**NRC Staff  
Request for Additional Information  
on  
Electric Power Research Institute Report 3002005564,  
“Development of Generic Scaling Factors for Technetium-99 and Iodine-129 in Low and  
Intermediate Level Waste”**

The NRC staff has reviewed EPRI Report No. 3002005564 and developed this request for additional information (RAI) to obtain sufficient information to decide whether to approve for use the findings documented in EPRI Report No. 3002005564. To conduct its detailed review, the NRC staff considered the following regulations (and related NRC guidance) from Title 10 of the *Code of Federal Regulations* (10 CFR) in its evaluation:

**Figure 1.** Ratio of I-129 to Cs-137 in Samples Analyzed in NUREG/CR-6567

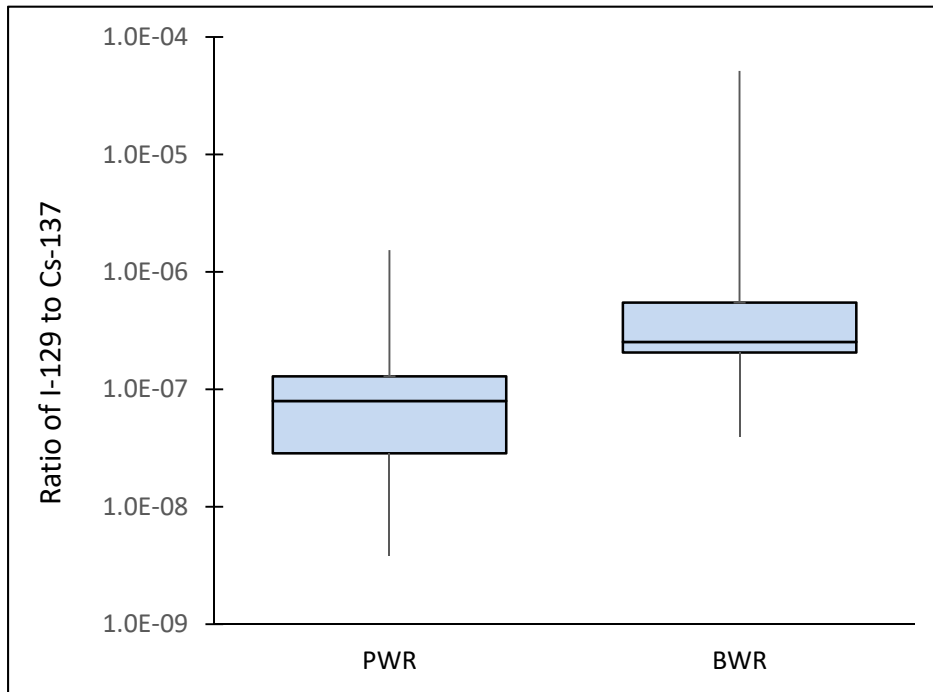
However, an independent evaluation of the NUREG/CR-6567 data by the NRC staff found that calculated ratios of I-129 to Cs-137 were generally higher for the BWR samples than samples from Pressurized Water Reactors (PWRs) (**Error! Reference source not found.**). The geometric mean of the I-129-to-Cs-137 ratio from all BWR samples was  $4.2 \times 10^{-7}$  while the geometric mean from all PWR samples was  $6.5 \times 10^{-8}$ . Based on the data in NUREG/CR-6567, it appears that the use of the proposed scaling factor could result in the underestimation of the activity of I-129 in LLW from BWRs.

- (a) Provide justification that the proposed scaling factor for I-129 based on the measured Cs-137 activity is appropriate for all LLW from BWRs. Alternatively, provide a description of and basis for the specific conditions under which it would be appropriate to use the proposed scaling for LLW from BWRs.
- (b) Provide information on the representativeness of the two samples for which the use of the proposed I-129/Cs-137 scaling factor would result in more than a factor of 10 underestimation in the activity of I-129. If the samples are determined to be not representative of BWR LLW, provide a description of what properties of the waste and/or plant conditions caused the samples to not be representative.

**Figure 2.** Ratio of measured I-129 to predicted I-129 based on the proposed scaling factor

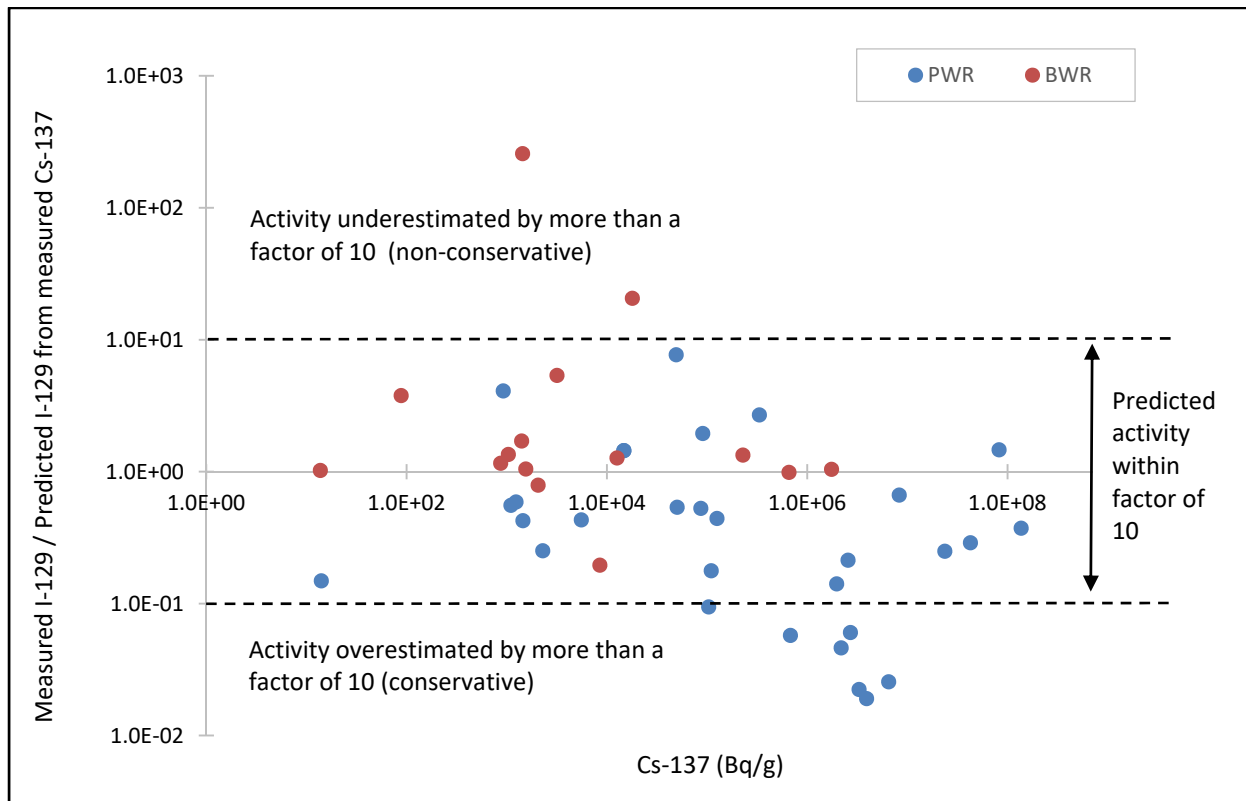
Additionally, this scaling factor would have resulted in the underestimation of the I-129 by more than an order of magnitude in two of the NUREG/CR-6567 BWR samples (Figure 2). It is not clear if these samples are representative of typical BWR LLW or if there is a known explanation for why the relative ratio of I-129 to Cs-137 might differ for these samples. If the samples are believed to be representative of typical BWR LLW, then the data from these results indicate that there is not reasonable assurance that the proposed scaling factor would result in a predicted activity of I-129 that is within a factor of 10 of the actual activity. However, if the samples are not representative of BWR LLW, then the proposed scaling factor could be restricted to waste streams that do not have the same properties as those samples.

**Figure 3.** Ratio of measured I-129 to predicted I-129 based on the proposed I-129/Co-60 scaling factor

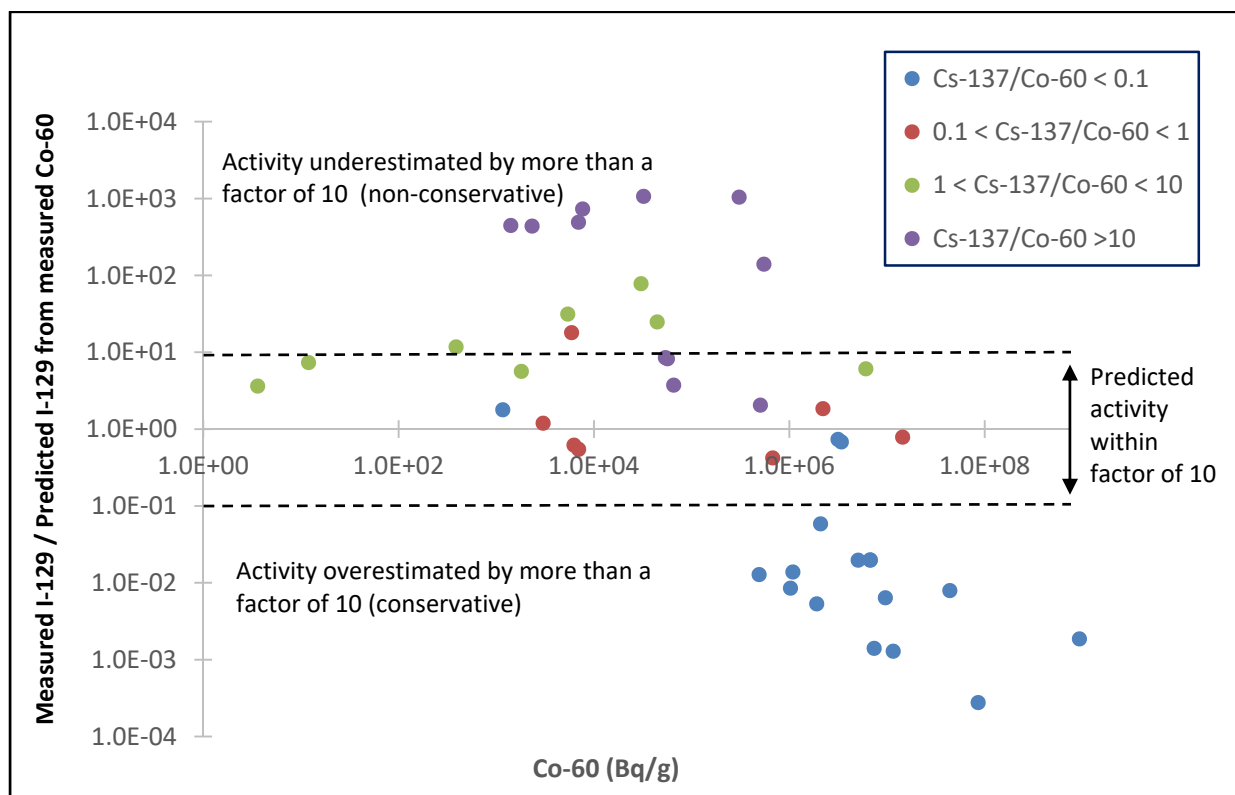
An independent analysis by NRC staff found that the use of the I-129/Co-60 scaling factor consistently resulted in an acceptable prediction of the I-129 activity for the waste streams in the NUREG/CR-6567 (NRC, 2000) dataset when the ratio of Cs-137 to Co-60 was less than 0.1 (Figure 3), which would be expected to be true when Cs-137 is not present in detectable quantities. However, Cs-137 was detected in all these samples and there are no sample measurements that can be used to confirm that the scaling factor is appropriate when the activity of Cs-137 is below the detection limit.

- (a) Justify that the I-129/Co-60 scaling factor is appropriate when Cs-137 is not present above the detection limit by providing the following information:
  - (i) A description of the range of conditions under which the use of the I-129/Co-60 scaling factor is appropriate and the situations that could lead to a change in the correlation or cause the indirect method to no longer be appropriate; and
  - (ii) Additional information to demonstrate that the data used to generate the I-129/Co-60 scaling factor is applicable when Cs-137 is not present above the detection limit given that Cs-137 was detected in all the samples considered in EPRI Report No. 3002005564.

**Figure 4.** Ratio of measured Tc-99 to predicted Tc-99 based on the proposed Tc-99/Co-60 scaling factor

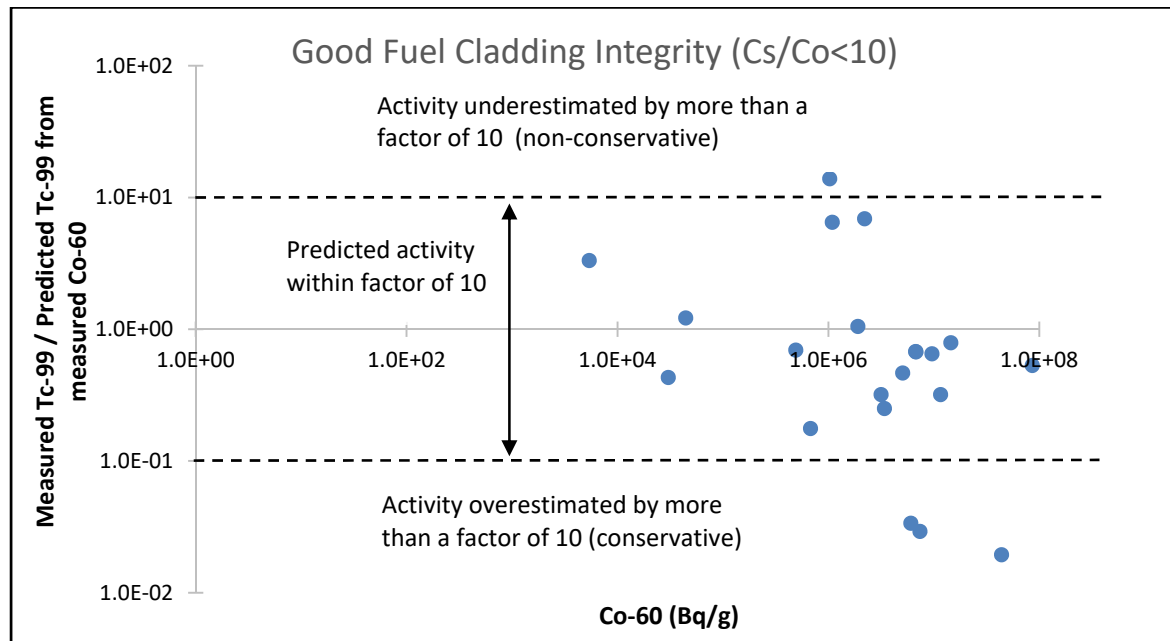
An independent analysis by the NRC staff found that the use of the Tc-99/Co-60 scaling factor consistently resulted in an acceptable prediction of the Tc-99 activity for the samples in the NUREG/CR-6567 (NRC, 2000) dataset except for one sample (Figure 4). Based on this, it appears that there are some conditions under which the proposed Tc-99/Co-60 scaling factor would not adequately estimate the activity of Tc-99. A description of the conditions under which this scaling factor would not be applicable is needed.

- (a) For the NRC staff to conclude that it is appropriate to predict the Tc-99 activity based on the Co-60 activity, the following information is needed:
  - i. Additional data to support the conclusion that the relative ratio of Co-59 to Mo-98 is relatively consistent from plant to plant and over the operating history of the power plants; and
  - ii. A description of the range of conditions under which the use of the Tc-99/Co-60 scaling factor is appropriate and the situations that could lead to a significant change in the correlation that would cause the proposed scaling factor to no longer be appropriate.

**Figure 5.** Ratio of measured Tc-99 to predicted Tc-99 based on the proposed Tc-99/Cs-137 scaling factor

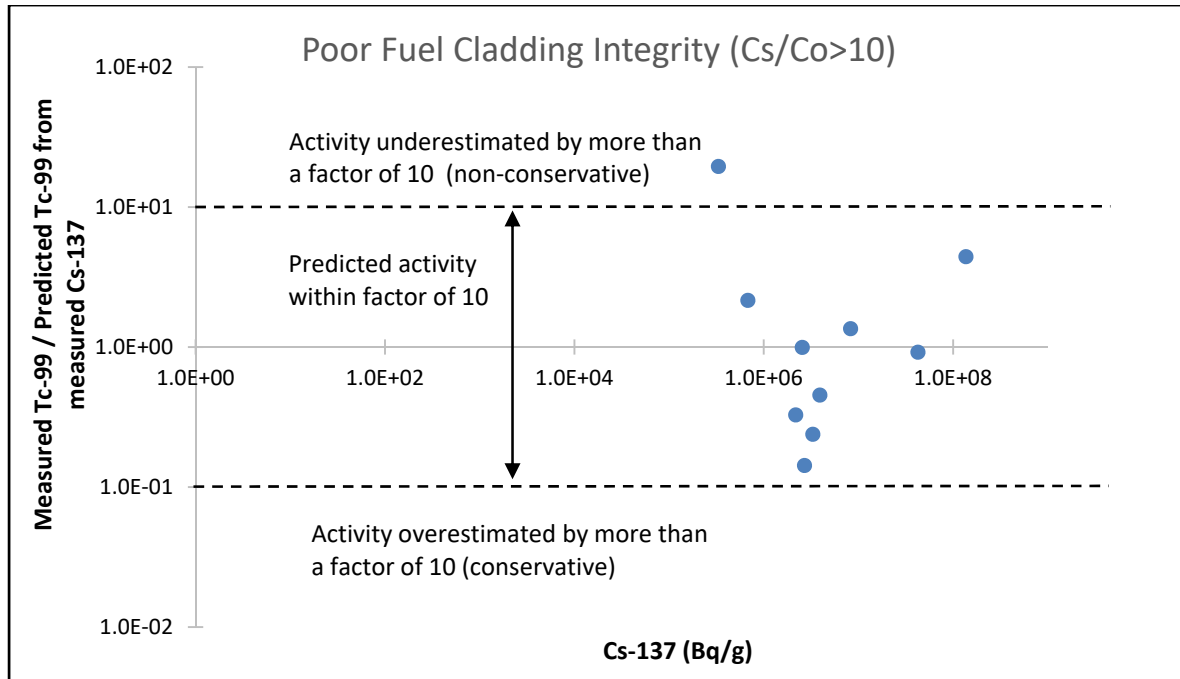
An independent analysis by the NRC staff found that the use of the Tc-99/Cs-137 scaling factor consistently resulted in an acceptable prediction of the Tc-99 activity for the samples in the NUREG/CR-6567 dataset except for one sample (Figure 5). Based on this, it appears that there are some conditions under which the proposed Tc-99/Cs-137 scaling factor would not adequately estimate the activity of Tc-99. A description of the conditions under which this scaling factor would not be applicable is needed.

- (b) For the NRC staff to conclude that it is appropriate to predict the Tc-99 activity based on the Cs-137 activity, the following information is needed:
- i. A basis for concluding that a sufficient number of samples was collected to have reasonable assurance that the proposed Tc-99/Cs-137 scaling factor is appropriate or provide additional measurement results demonstrating that this scaling factor is appropriate;
  - ii. If the proposed Tc-99/Cs-137 scaling factor is intended for use for LLW other than other than PWR resin, a justification that the PWR resin data are applicable to other waste streams; and
  - iii. A description of the range of conditions under which the use of the Tc-99/Cs-137 scaling factor is appropriate and the situations that could lead to a significant change in the correlation that would cause the proposed scaling factor to no longer be appropriate.
